SERVICE BULLETIN

SB No. **L-410/163b**

Aeroplane Type: **L-410**

Subject: Check and possible replacement of the B535 406N clamps of autopilot rudder servo actuator cables.

Detail VI₆

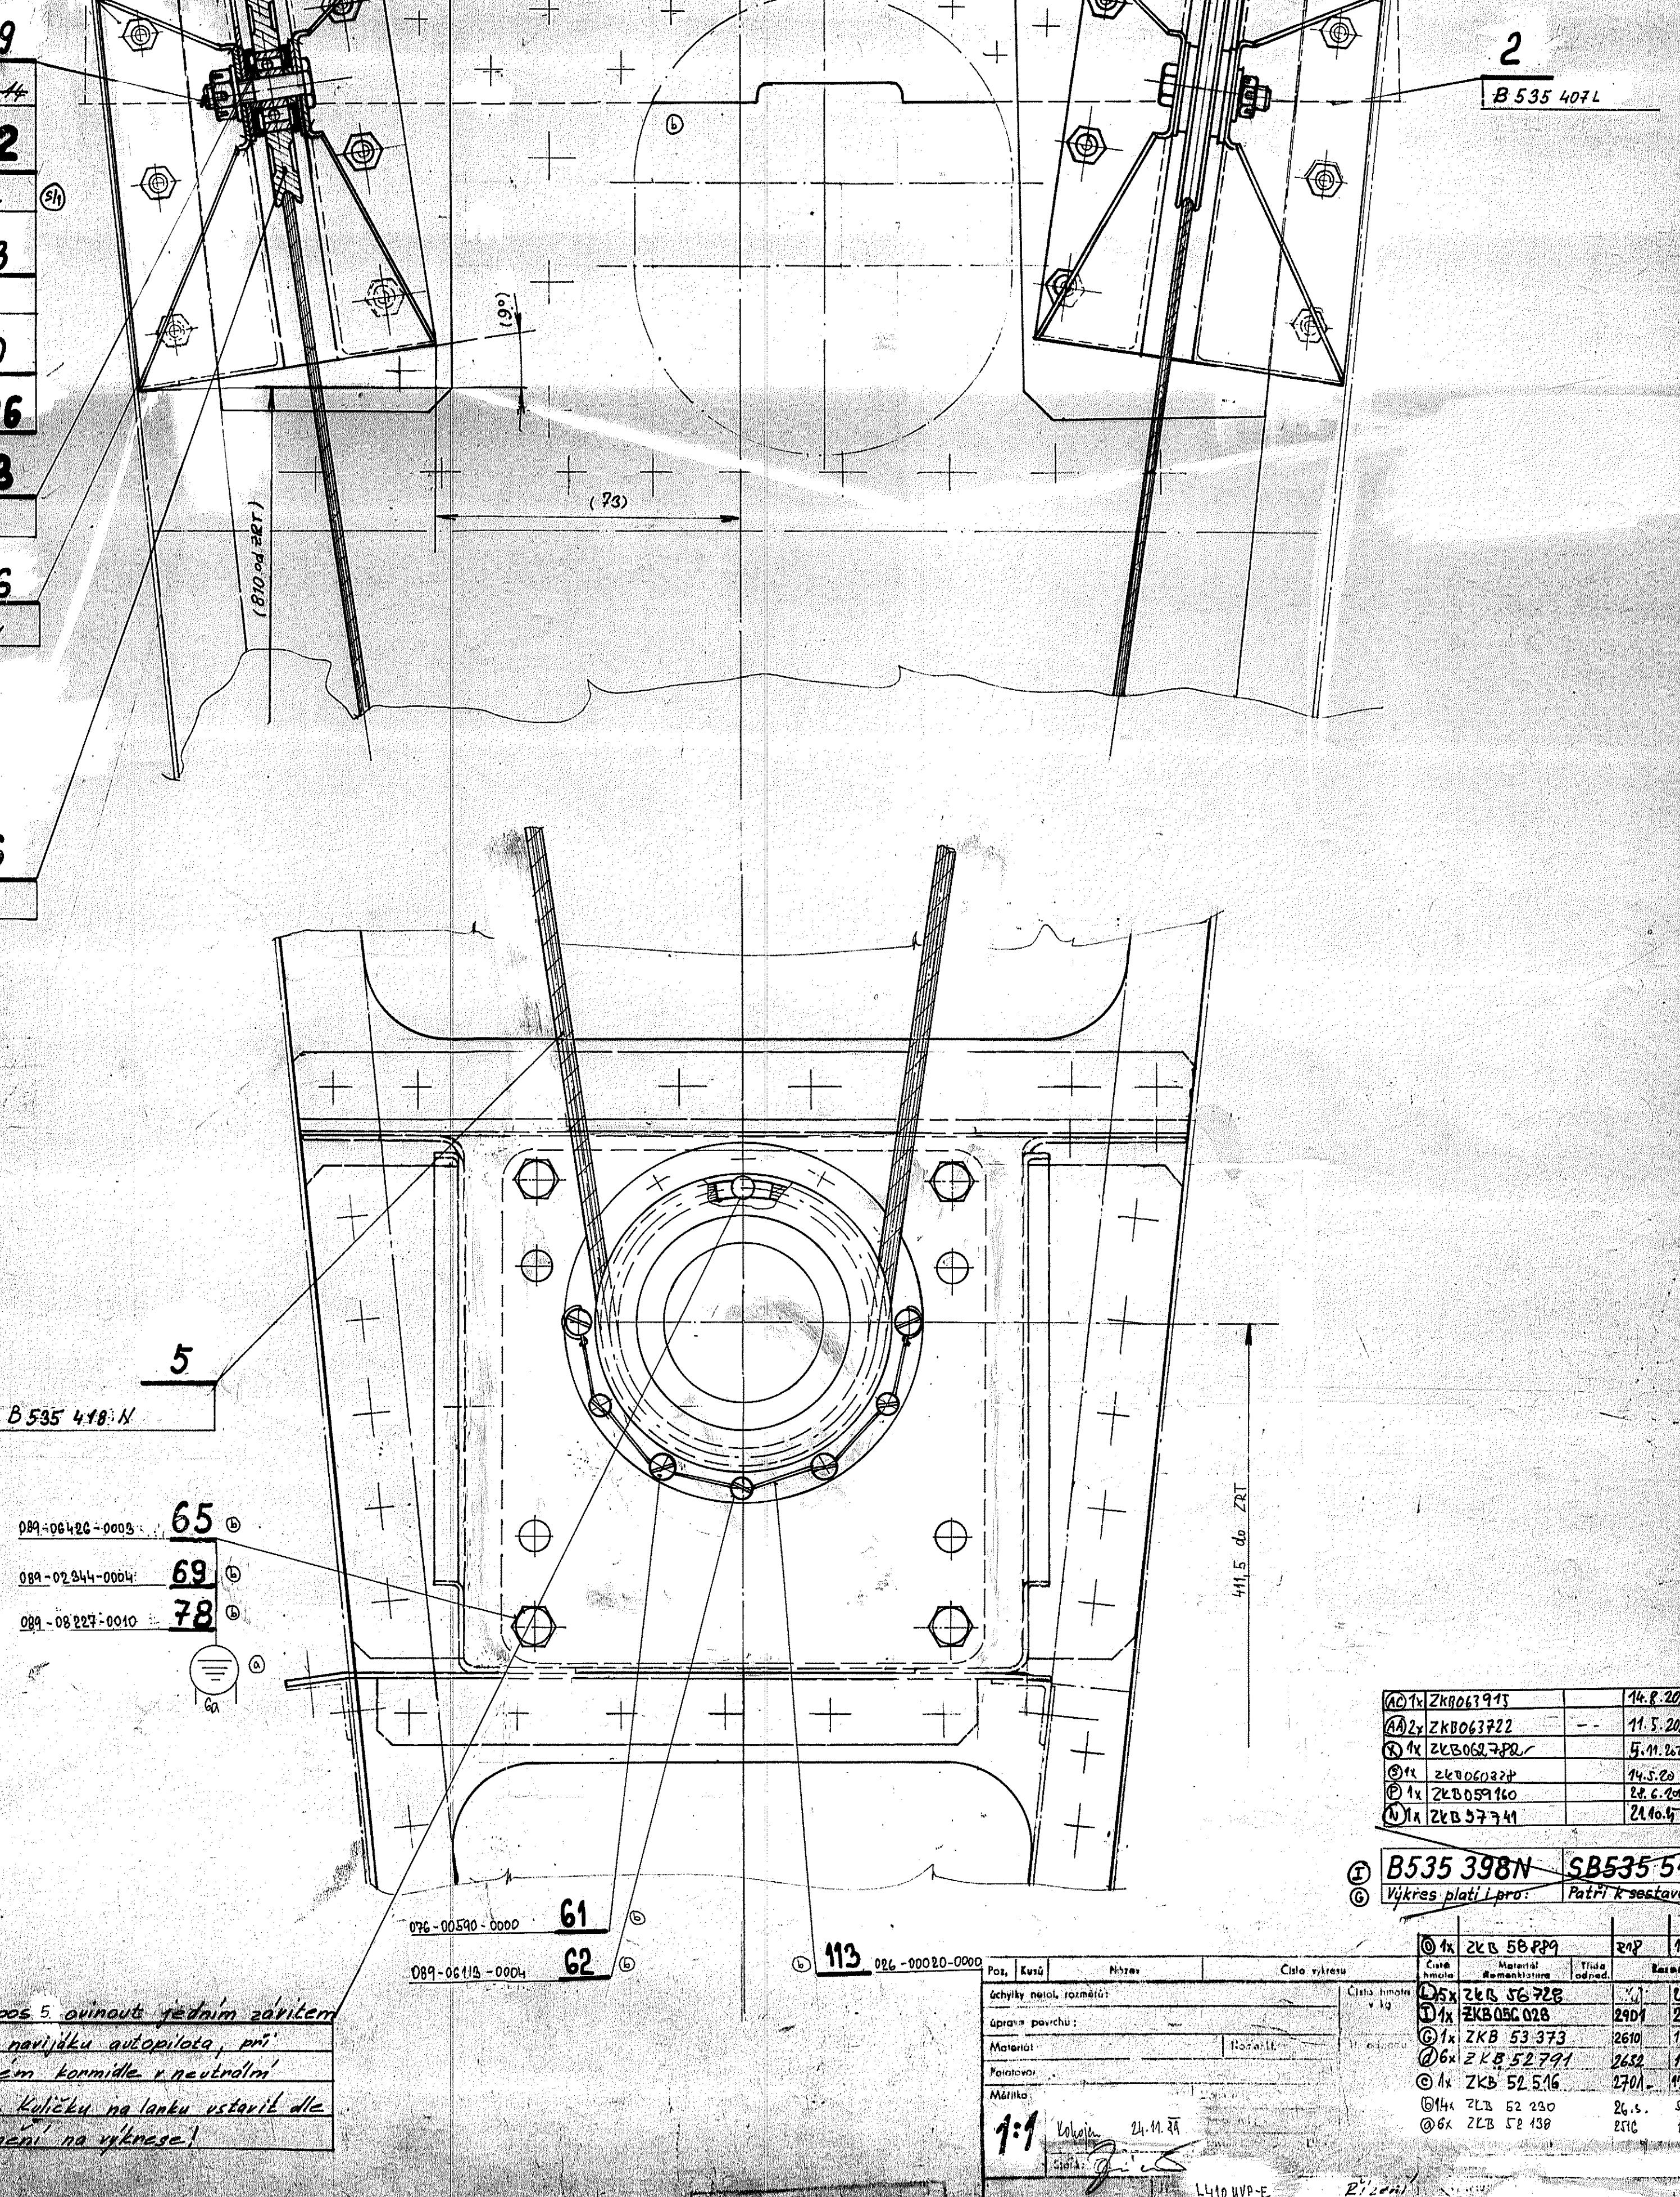
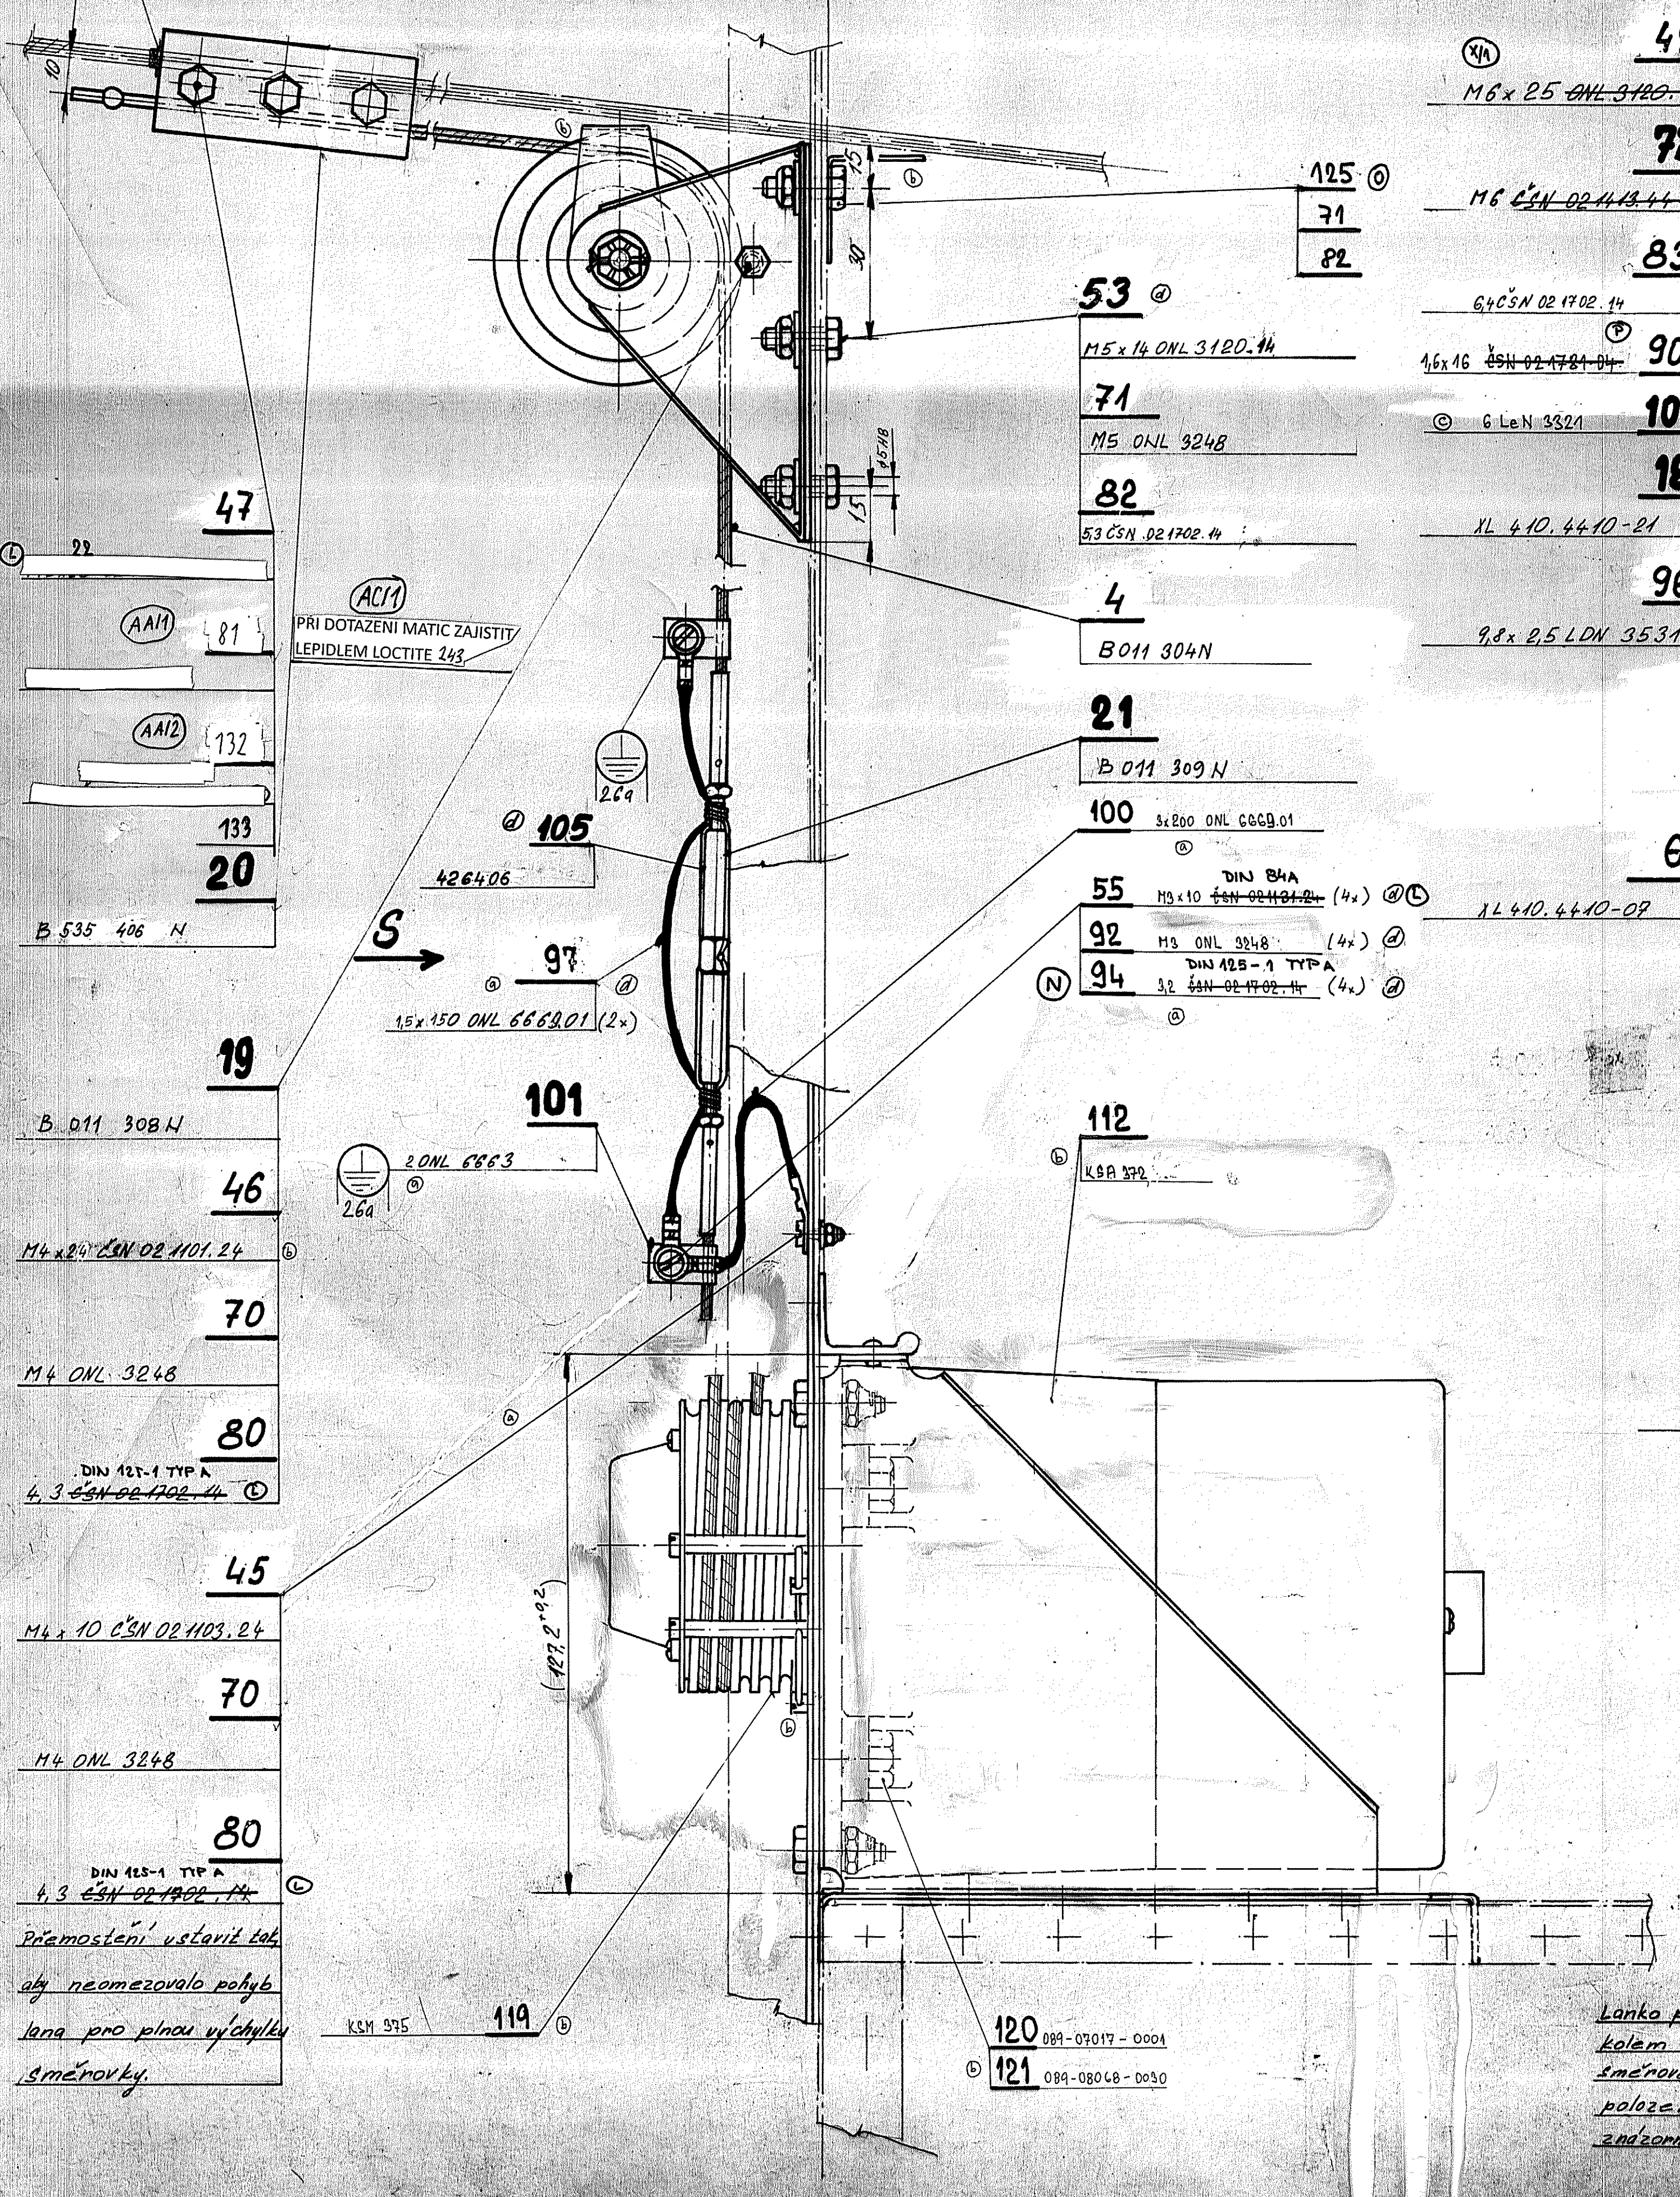
- Check that the clamps pos. 20, Dwg No. B535 401N sheet 6, Detail VI6 on the rudder control cables have not shifted by means of the red marking.
 - If the clamps have not shifted, make a record in the Aeroplane Logbook according to the point 4. of this bulletin.
 - If any of the clamps has shifted, replace both original clamps by new ones together with fasteners according to the points 2.C., 2.D. of this bulletin.

- Cut and remove locking wires and loosen the turnbuckles pos. 21, Dwg No. B535 401N sheet 6, Detail VI6.
- Unscrew the original nuts pos. 132, remove washers pos. 81, pull out screws pos. 47 and remove original clamps pos. 20.

- Carefully degrease the rudder control cables with benzine at location of the clamps pos. 20, Dwg No. B535 401N sheet 6, Detail VI6.
- Install new clamps pos. 20 (appropriate groove radius must be set on approp. diameter of a cable) by means of new fasteners pos. 47, 81, 132 and torque the nuts to 5 - 6 Nm. A gap between halves of a clamp must be at least 0.8 mm. Secure the nuts with Loctite 243 according to the MM, sect. 020.20.00, page 845. Use material pos. 1 to 4 of point 3.A. of this bulletin and pos. 1 of point 3.B.

- Adjust the cable tension by means of the turnbuckles pos. 21 according to the MM, sect. 022.10.00, point 1.E.(15), page 408, table 401 (or point 1.E.(8), page 406, table 402 for L-420). **The thread of the cable end must be hidden in the turnbuckle by at least 8 mm!**

- Secure the turnbuckles pos. 21 and fix the bonding with locking wire. Use material pos. 5 of point 3.A. of this bulletin.
